Barangaroo Stage 1B Public Domain

*State Significant
Development
Modification Assessment
(SSD 7944 MOD 1)*

October 2019

Figure 10 | A site plan of the interim design solution for the interface between Hickson Road and Hickson Park
(Source: Applicant)

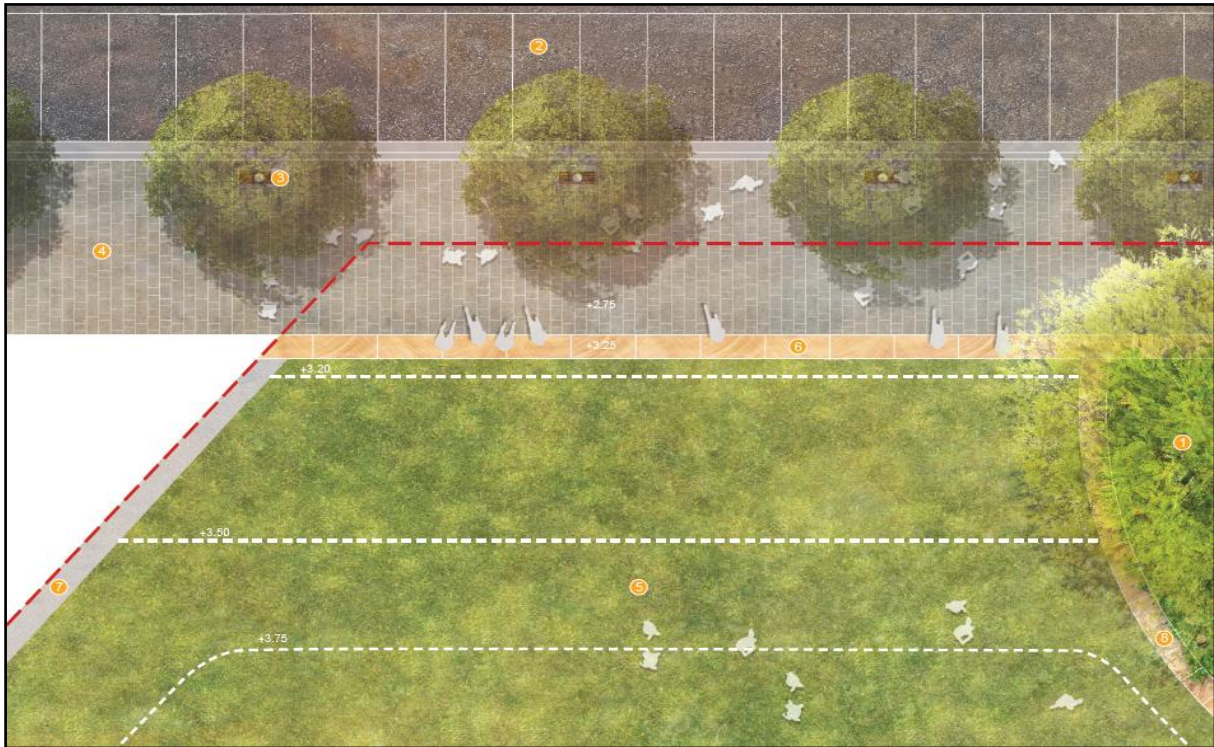
Until Hickson Road is raised, the Applicant is proposing an interim design solution to manage its interface with Hickson Park (**Figure 10**). The interim solution proposes a low, 500 mm sandstone block wall to Hickson Road. The temporary solution will ensure the park will be developed to comply with the required deep soil volumes and be maintained until final road levels are constructed. Once Hickson Road is raised, the interim design solution will be removed, and a permanent design solution will be developed by Infrastructure NSW.

Council also requested the Applicant produce a Public Domain Plan in consultation with its Public Domain Unit to focus on the footways and interfaces with Hickson Road. The Applicant noted Infrastructure NSW is responsible for the design and construction of Hickson Road (including the footways that adjoin to Hickson Park) and will consult with Council during the planning process.

The Applicant advised the proposed levels at Hickson Park on the eastern edge were nominated by Infrastructure NSW to meet the raised levels of Hickson Road in the future. Consequently, the Applicant considers a temporary wall is required in this location due to the substantial difference between the proposed level of Hickson Park and the current level of Hickson Road. The Applicant notes Hickson Park will still remain

permeable and easy for pedestrians to access, with multiple entries and exits to and from Hickson Road whilst the interim design solution is in place.

The Department considers raising the level of Hickson Park is acceptable as it would allow the park to integrate with the future upgrade of Hickson Road. The Department also notes the raised levels will assist with stormwater management and supports the improved embellishment and enhancement of the public domain by maintaining minimum soil depths.

Figure 12 | Deletion of precast concrete seats/bollards on eastern edge of Hickson Park (Source: Applicant)

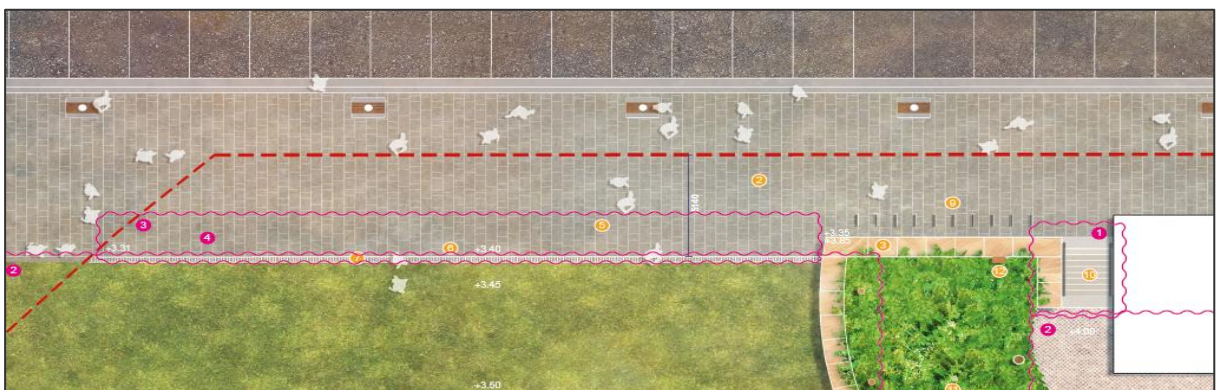
The original modification application sought to change the proposed sandstone bollards on the eastern and western edges of Hickson Park to precast concrete (**Figures 11 & 12**).

Council raised concerns the change of material to precast concrete will have little design finesse and the Applicant had not provided a justification for the reduction in quality of material, from sandstone to precast concrete.

The Applicant also seeks to increase the spacing between the concrete seats/bollards on the western edge of Hickson Park by at least 1.2m in appropriate places (**Figure 11**). The Applicant notes this change would accommodate prams and wheelchairs and promote pedestrian accessibility into Hickson Park. The Applicant also notes the concrete seats/bollards on the eastern edge will be removed and any permanent seats/bollards will be implemented by Infrastructure NSW during the Hickson Road upgrade (**Figure 12**).

The Applicant noted the change in material was required to better complement the paving (in grey tones) and strip drain, to increase long-term durability, reduce ongoing maintenance and ensure a high-quality appearance is maintained. Council subsequently reviewed the Applicant's RtS and accepted the proposed changes.

The Department considers the change of material to precast concrete to be acceptable due to the long-term benefits for the public domain including improved appearance, less ongoing maintenance and greater durability.

Figure 15 | The proposed pier at Watermans Cove (Source: Applicant)

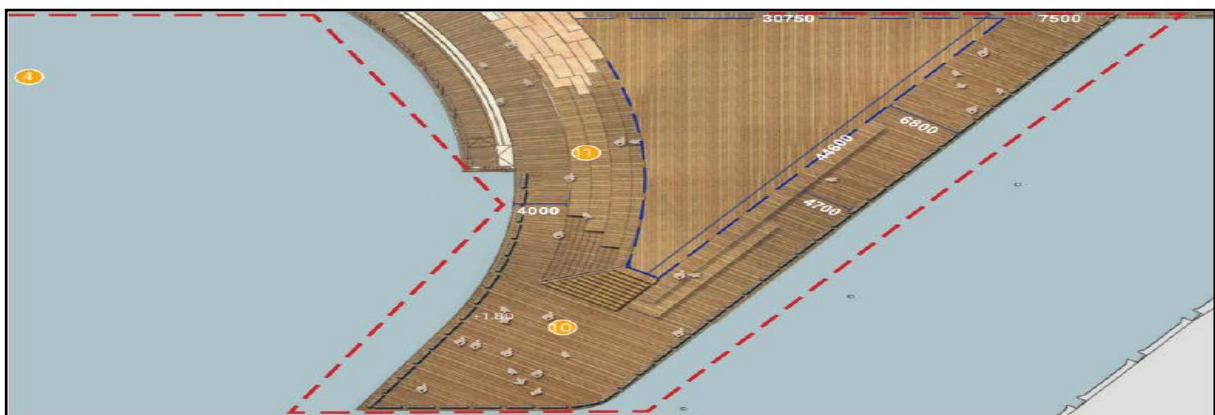
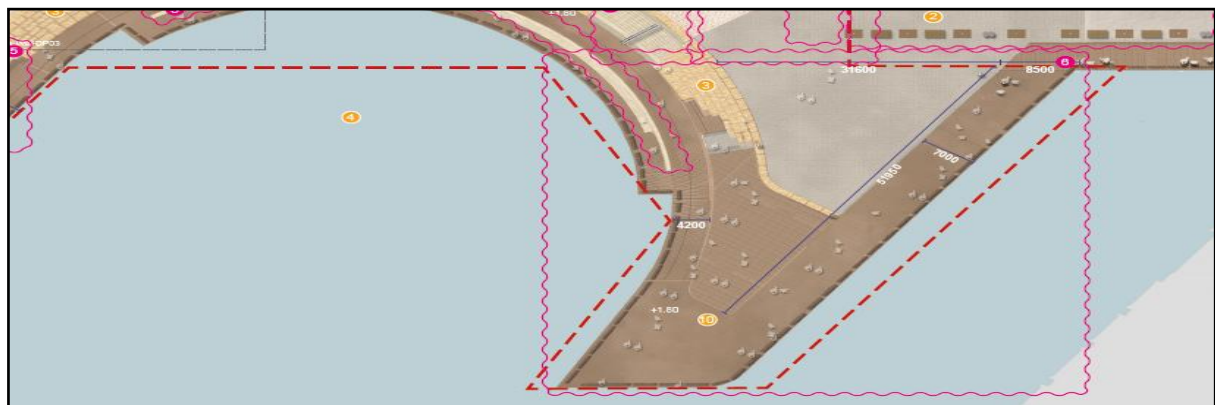
The public pier at Watermans Cove was approved with two tiers and integrated seating (**Figure 14**). Following a process of design refinement, the Applicant proposes the number of tiers be increased from two to three and the surface material of the upper tier changed from timber to hard paving (stone) (**Figure 15**).

The amendment to the number of tiers and hard paved upper level will assist with facilitating a range of events and activities in the future. The Applicant notes the overall envelope and extent of the pier over the Harbour is not proposed to change.

Figure 16 | Proposed removal of timber seating from raised planter in Watermans Quay identified as 1 (Source: Applicant)

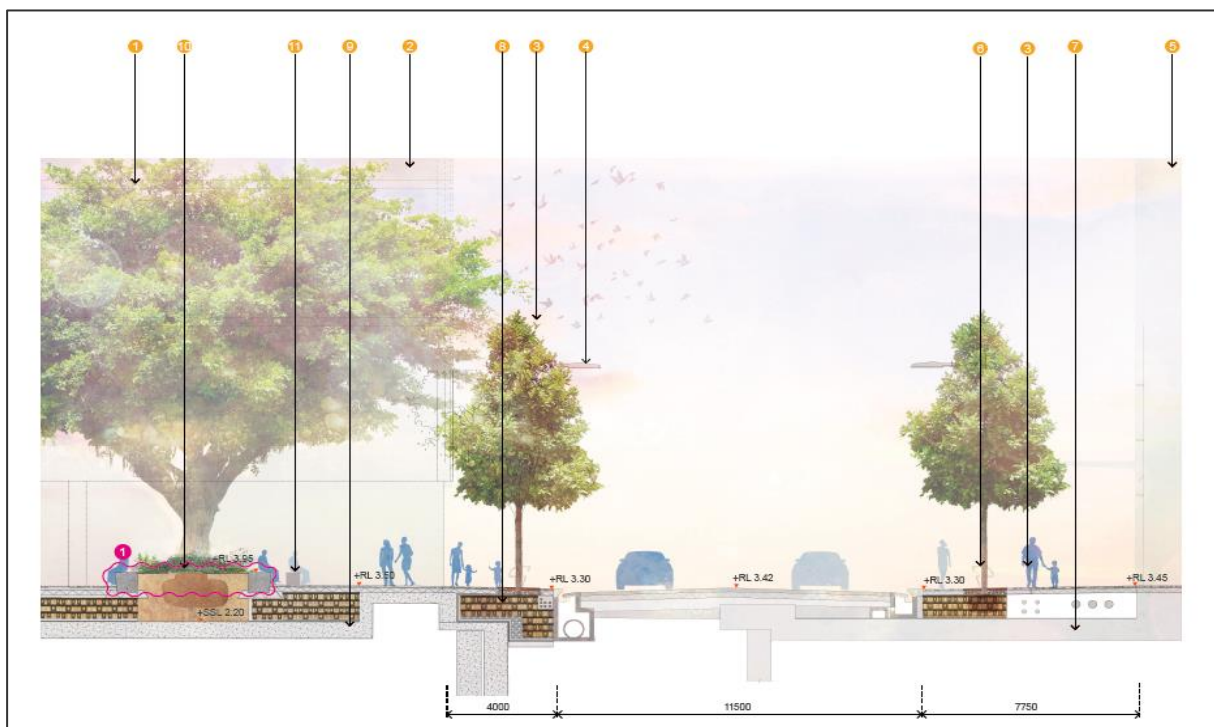
The modification also proposes to remove the porphyry paving and replace with the City of Sydney transition paving as per Condition B23 of the consent, minor bollard realignment and removal of timber top from Watermans Quay raised planter seating.

Council was originally concerned with the deletion of timber seating in Watermans Quay, noting the Applicant had not provided an alternative design with comfort in mind and no details of the planter design have been provided.

In the RtS, the Applicant responded to Council's concerns noting the change of timber seating to precast concrete was due to concerns the collection of debris from the canopy of fig trees above would negatively impact the day-to-day aesthetic. Council subsequently reviewed the Applicant's RtS and noted its issues had been addressed.

The Department considers the change of material to precast concrete to be an adequate mitigation strategy to protect the seating from debris and will improve the overall amenity of the public domain at Watermans Quay.

Figure 17 | Proposed removal of porphyry paving on Wulugul Walk identified as number 1 (Source: Applicant)

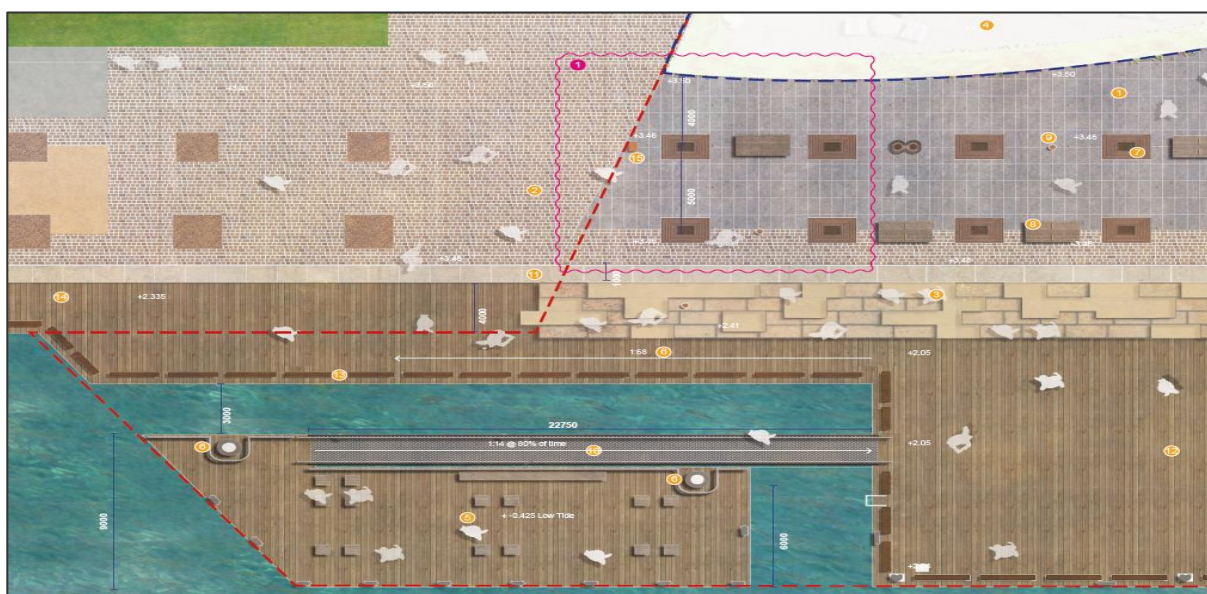
The modification seeks to make design and aesthetic changes to Wulugul Walk, including the removal of the porphyry paving that interfaces with Barangaroo Stage 1A and Barangaroo Central, and change to the Wulugul Walk granite paver. The Applicant proposes drainage grates to be removed along the porphyry band in Wulugul Walk and paving and tree pits are to be changed to match Barangaroo South Stage 1A public domain.

The modification also seeks to change the sandstone fascia design to the western side of the Spirit of Tasmania Landing, change the brass handrails to bronze, and update power point and water point locations.

The Department considers the modifications to porphyry paving, the sandstone fascia design and change of materials for the handrails located at Wulugul Walk to be minor and will ultimately provide consistency with the Stage 1A public domain. The Department notes the modifications will provide public benefit and improve the overall design and functionality of the site.
